**TRAFFIC CONTROL PLAN - ERIE AVE
BEGIN TO STA. 122+00**

**ERIE AVE/ORTT ST
IMPROVEMENTS**

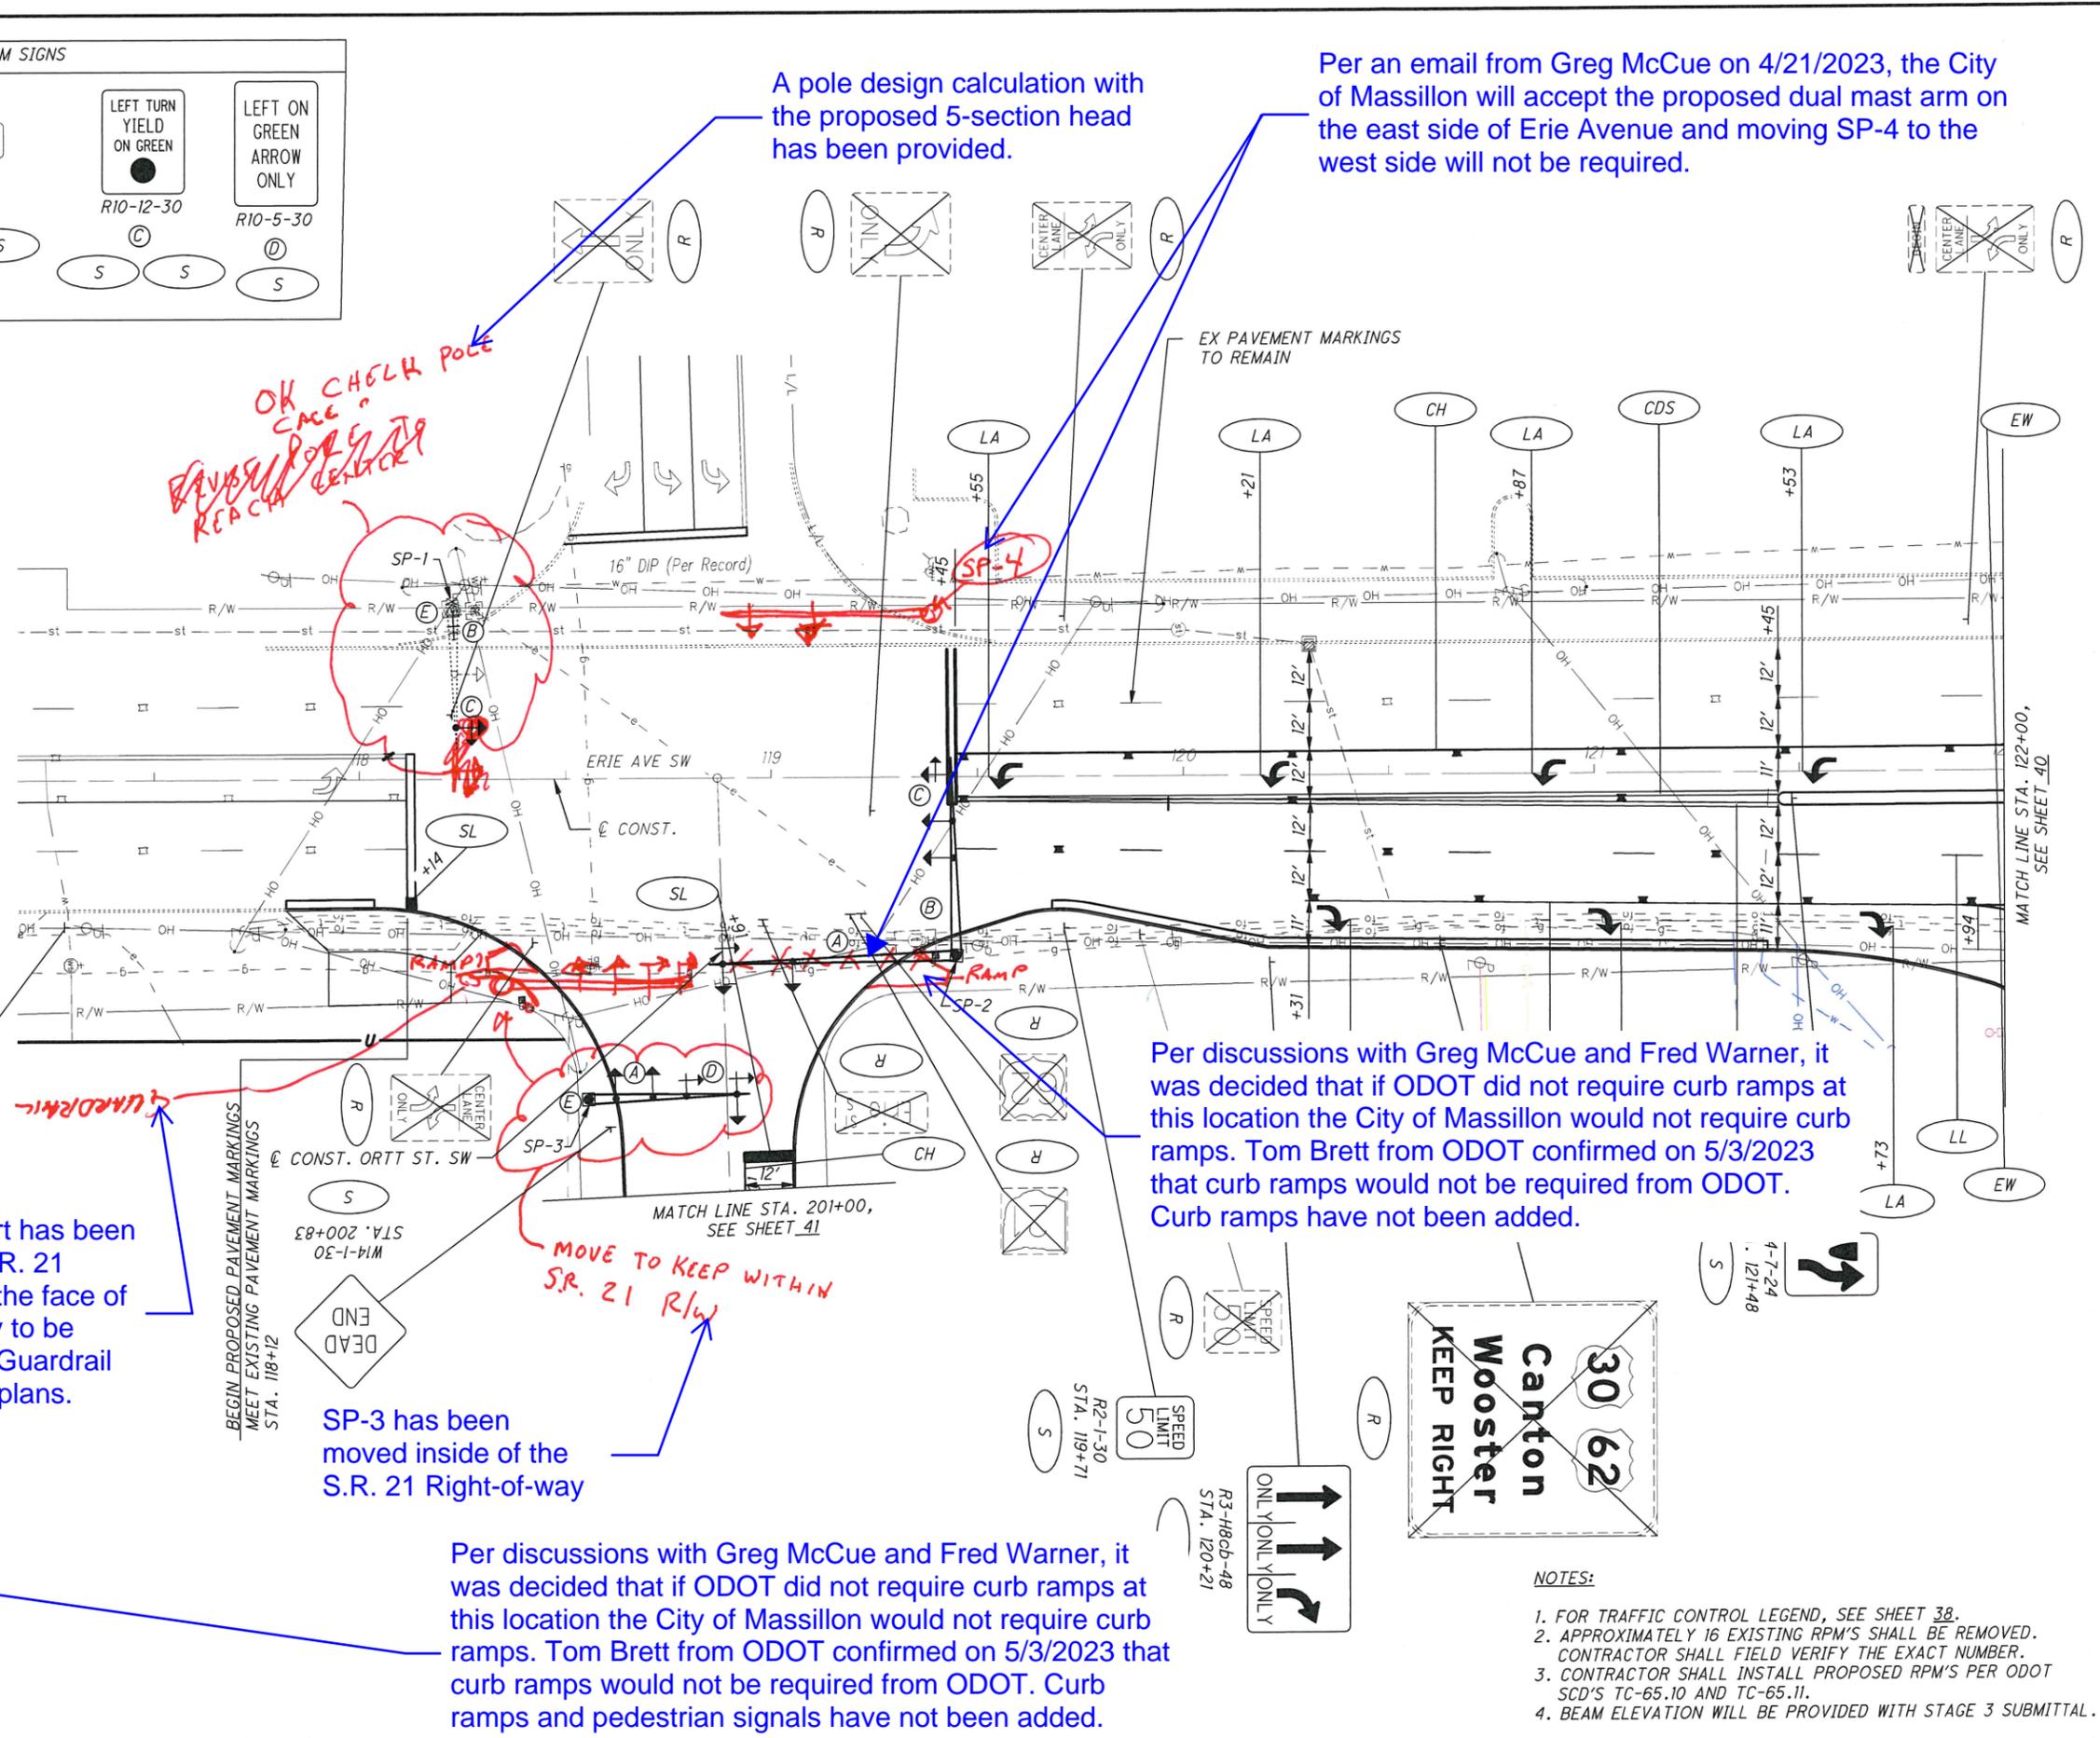
*OK CHECK POLE
CASE "A"
REACH CENTER*

*MOVE TO KEEP WITHIN
S.R. 21 R/W*

*PED SIGNALS?
RAMPS?*

A pole design calculation with the proposed 5-section head has been provided.

Per an email from Greg McCue on 4/21/2023, the City of Massillon will accept the proposed dual mast arm on the east side of Erie Avenue and moving SP-4 to the west side will not be required.

SP-3 has been moved inside of the S.R. 21 Right-of-way

Per discussions with Greg McCue and Fred Warner, it was decided that if ODOT did not require curb ramps at this location the City of Massillon would not require curb ramps. Tom Brett from ODOT confirmed on 5/3/2023 that curb ramps would not be required from ODOT. Curb ramps have not been added.

The proposed signal support has been moved to the back of the S.R. 21 Right-of-way and is 7.5' off the face of curb. Therefore is less likely to be struck by a turning vehicle. Guardrail has not been added to the plans.

Per discussions with Greg McCue and Fred Warner, it was decided that if ODOT did not require curb ramps at this location the City of Massillon would not require curb ramps. Tom Brett from ODOT confirmed on 5/3/2023 that curb ramps would not be required from ODOT. Curb ramps and pedestrian signals have not been added.
